Amendment  
Attorney Docket No.: 8932-471

Appl. No. 09/879,911  
Amdt. dated Sept. 29, 2003  
Reply to Office Action of May 28, 2003  
Replacement Sheet 5 of 9

FIG. 8a

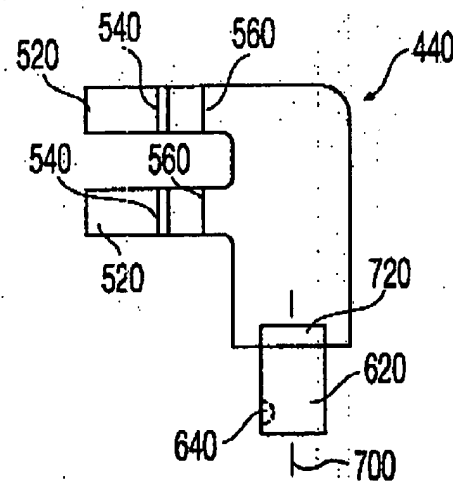
Replacement drawing sheet 5 of 9 is included in Appendix A. In response to the Examiner's objections to the drawings, applicants have submitted replacement drawing sheet 5 of 9 including the new FIG. 8a. An annotated drawing sheet has also been provided for the Examiner's reference. FIG. 8a shows a detachable blades 440 having a mating portion in the form of a post 620 for reception in bore 60 in jaw 14. The post 620 of blades 440 is shown preferably including a depression 640 for a ball detent attachment within bore or socket 60 and a stop plate 720 for limiting the range of pivotal motion of blade 620 about the longitudinal axis 700. Blades 440 are also shown having distracting surfaces 520 which may preferably further include vertebral engagers 540 and transverse engagement walls 560. No new matter is believed to have been added by this replacement drawing sheet.

Applicants draw the Examiner's attention to the specification and claims of the application as filed for support of the replacement drawing sheet. Specifically, FIG. 8a shows all the features associated with detachable blade as provided in claims 7 and 9-16 as originally filed. In addition, blades 440 of FIG. 8a reflect the described detachable alternative to the *preferred* embodiment of blades 244, shown in Fig. 16 and described at page 12, lines 5-12 of the application as originally filed. The Examiner is respectfully requested to approve the drawing changes. Amendments to the specification are shown above and described below to reflect the changes in replacement drawing sheet 5 of 9.

FIG. 8 CORRECTION OF REFERENCE NUMERAL

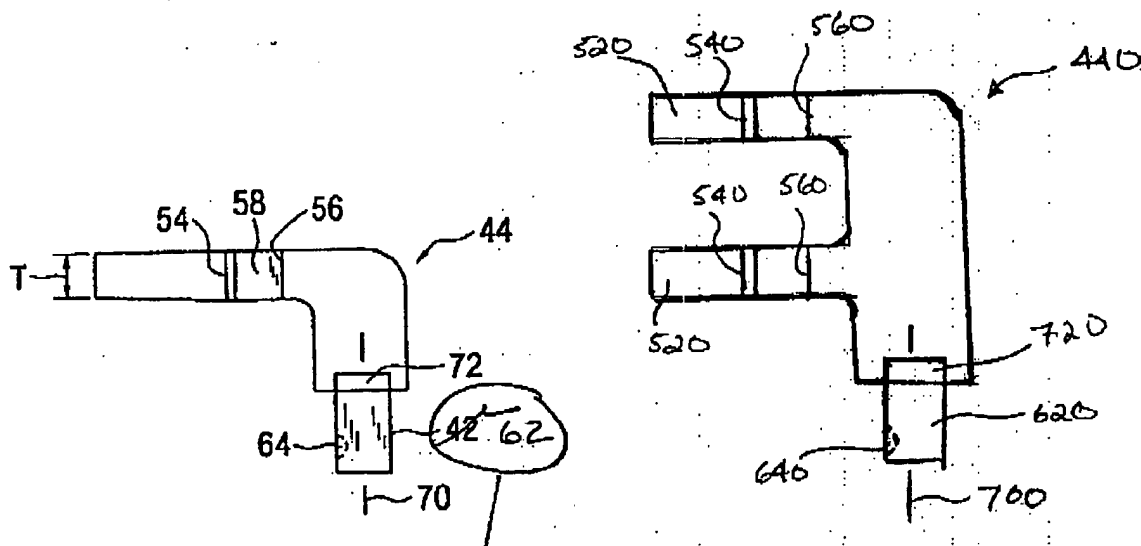
FIG. 8a (ADDED)
